EXAMINER'S TELEPHONE CONFERENCE CALL

REMARKS

Revised Specification Paragraphs (Marked-Up Version)

Figure 4A-14

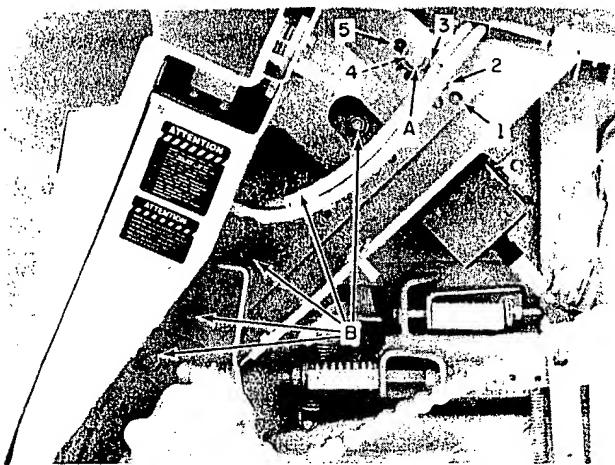
As shown in Figure 4A-14 of the operating manual, the elements referred to as "B" by the examiner in the Rayfield patent are also labeled B in figure 4A-14. The operator's manual then goes on to state the following:

To change the feeder face plate angle, remove bolt A, Figure 4A-14, from both sides of the feeder. Loosen the five bolts, B, on both sides of the feeder.

Figure 4A-15

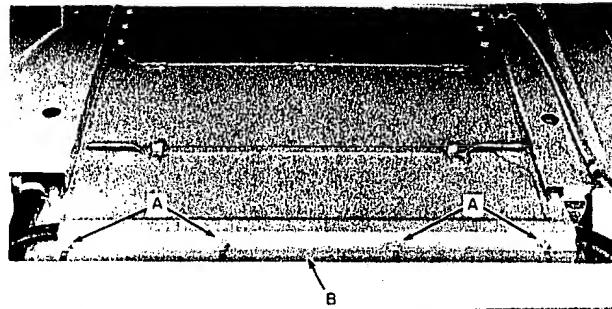
Loosen bolts, A, Figure 4A-15, along the back edge of the face plate. Move the face plate to the desired position. Reinstall the top two bolts and tighten the remaining hardware. Slide plate, B, forward until it contacts the face plate or until the slotted holes in the plate bottom. Tighten hardware, A.
